North Westerly - PD zoning 3rd Review

To: John Prestwich, PCS Group
From: Aly Burkhalter, Senior Planner
Date: January 16, 2025
Re: PD-001700-2024 North Westerly - PD

3rd Review & Referral Comments

A PARCEL OF LAND LOCATED IN SECTION 16, TOWNSHIP 1 NORTH, RANGE 68 WEST OF THE SIXTH PRINCIPAL MERIDIAN,
TOWN OF ERIE, COUNTY OF WELD, STATE OF COLORADO
390.8797 ACRES
PD-001700-2024
ZONING MAP

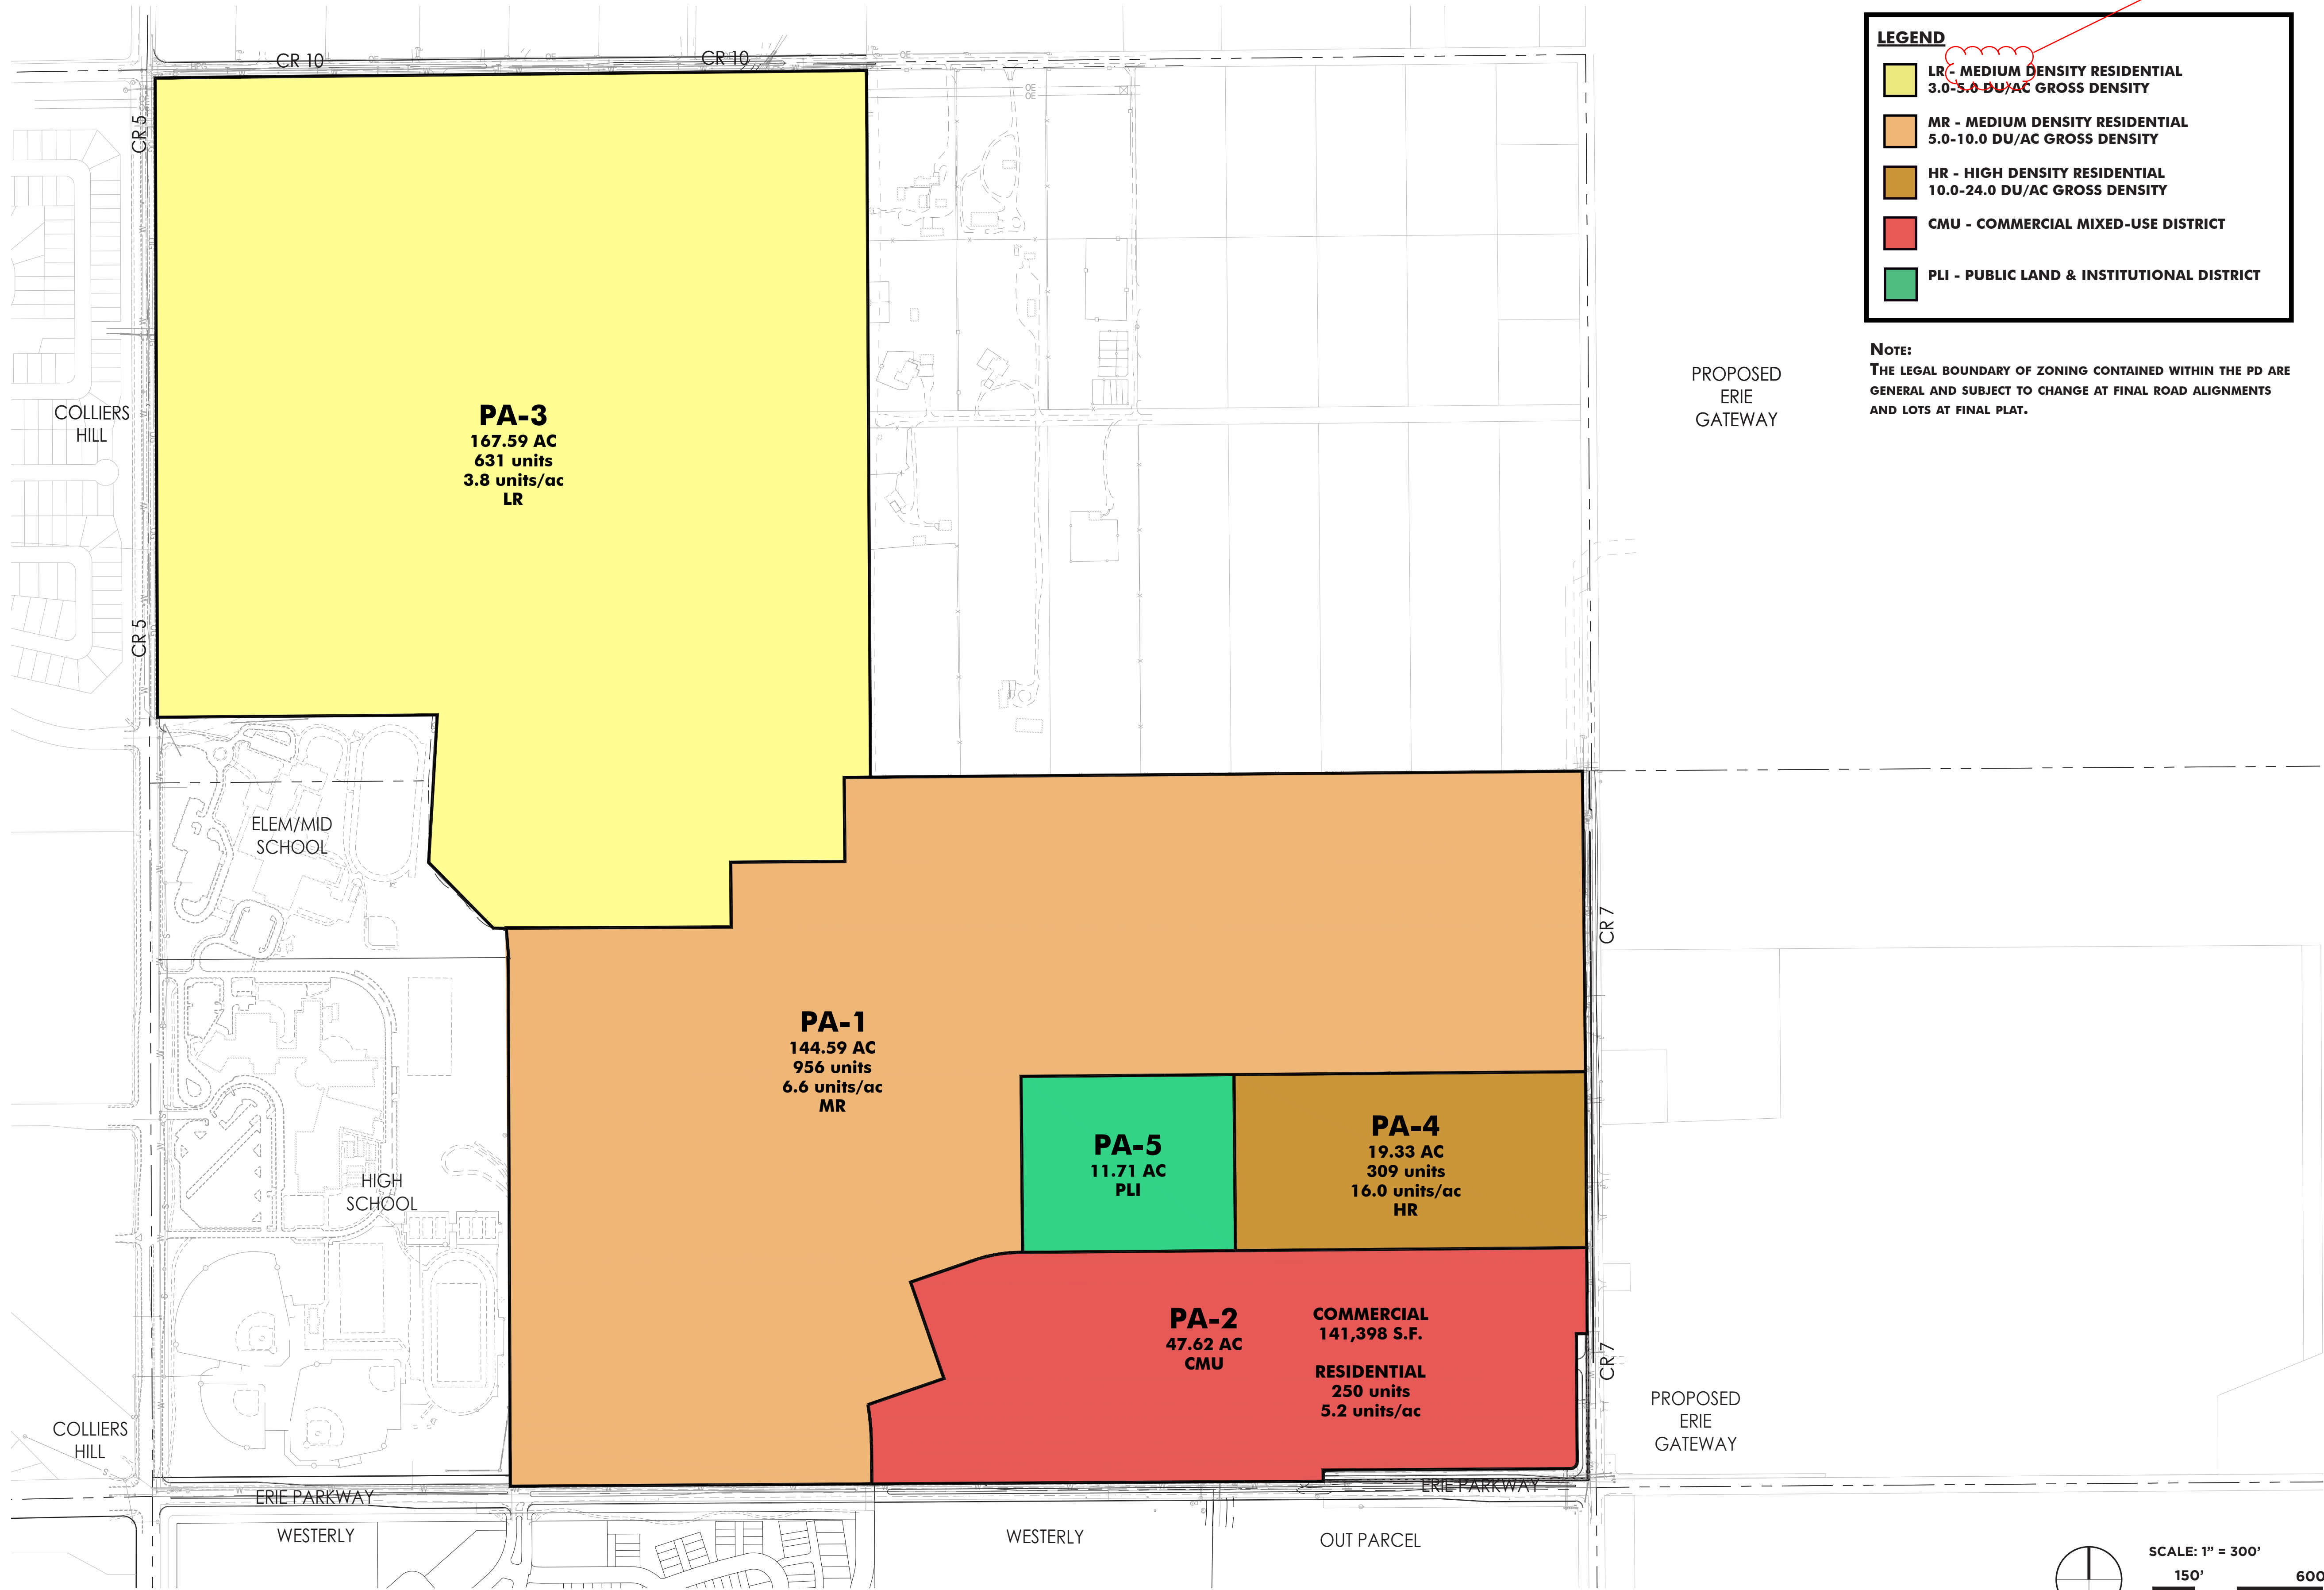
New comment #135 at 3rd
submittal: The legend for LR
shall state "low" instead of
"medium".

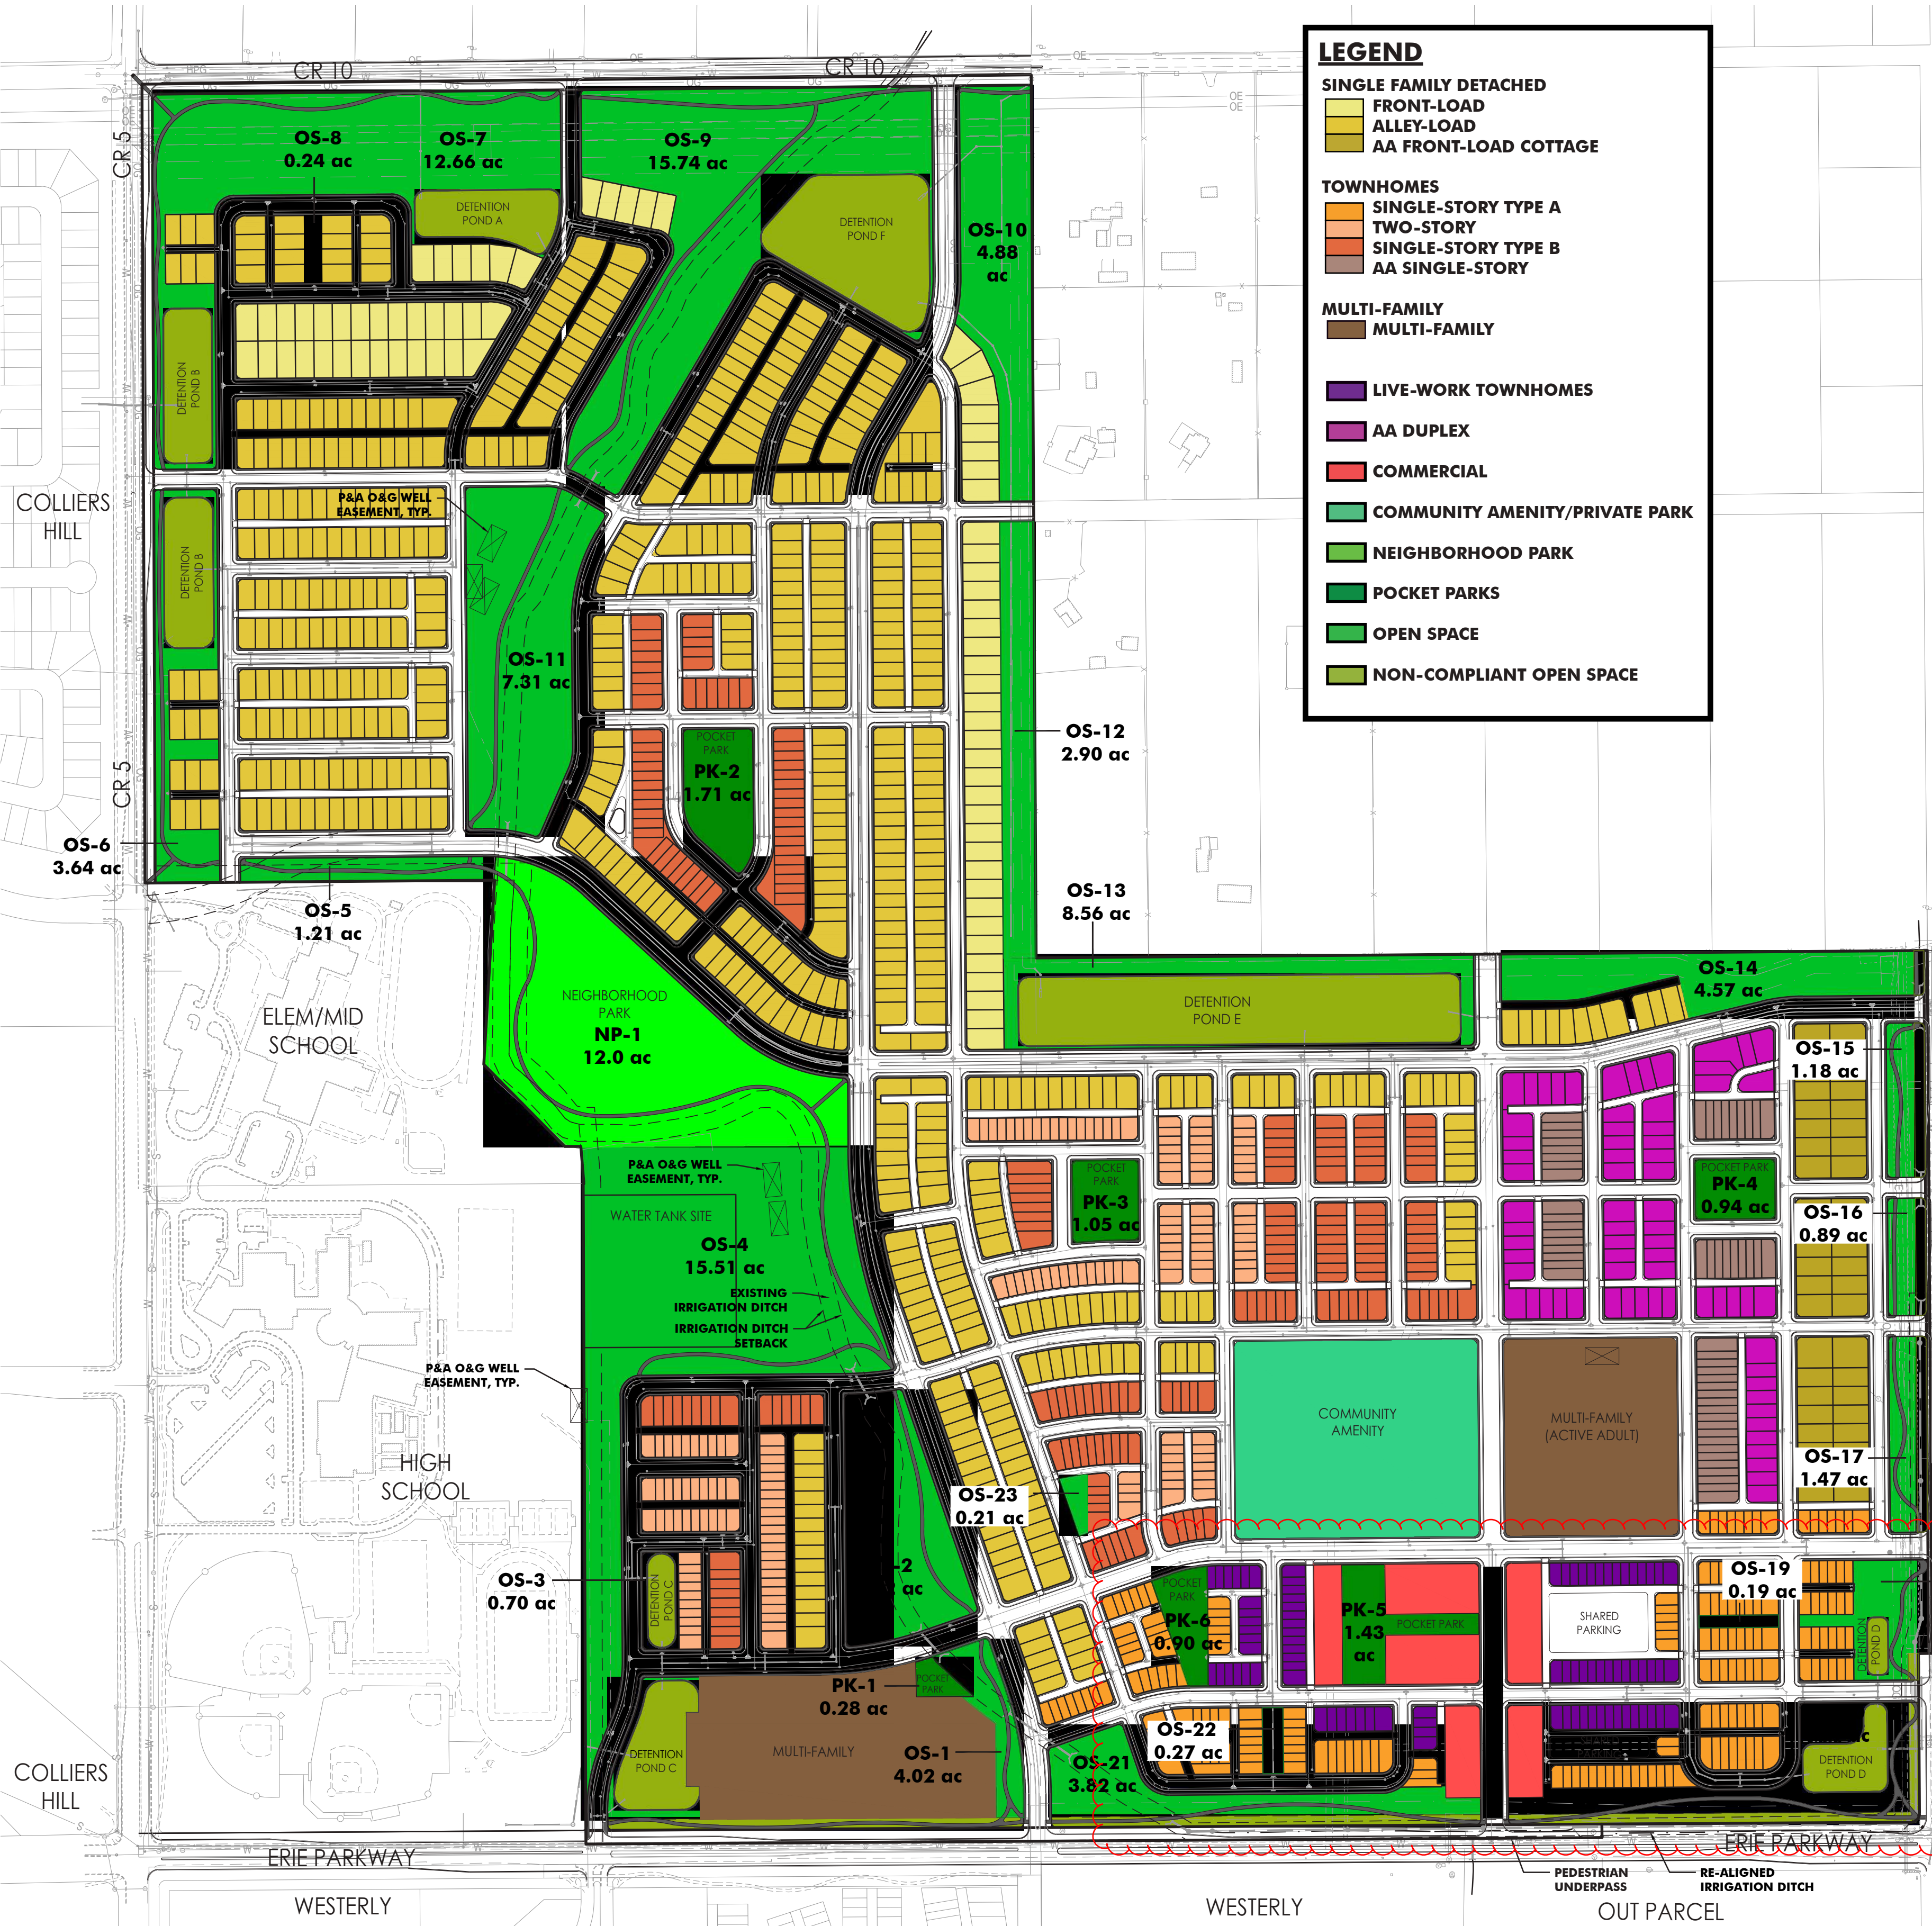
New comment #136 at 3rd submittal: Per Sheet 3 Concept Plan, it appears there are townhomes (single story Type A) in the CMU zone district/PA-2 which is not permitted by right in the CMU zone district by UDC 10-3-1 Permitted Use Table. Please add a note to Sheet 2 Zone Map and Sheet 3 Concept Plan: "Uses are permitted by right per the underlying zone district with the addition of allowing townhomes in CMU zone districts as shown on the Concept Plan."

New comment #137 at 3rd submittal: please add commercial square footage number to PA-2 row. Per the Market Study and Economic Development review, staff requests the number be updated to a round number of 150,000sf.

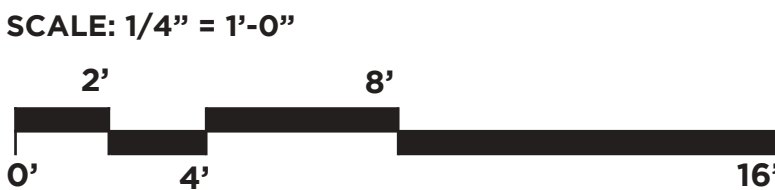
128. [Sheet 17 Overall Lighting Plan] If you are using the same fixtures of the existing Westerly neighborhood. Please provide a scaled fixture design with height label. Applicant 3rd submittal response: We have added the fixture with the height labeled. Town 3rd review response: Resolved
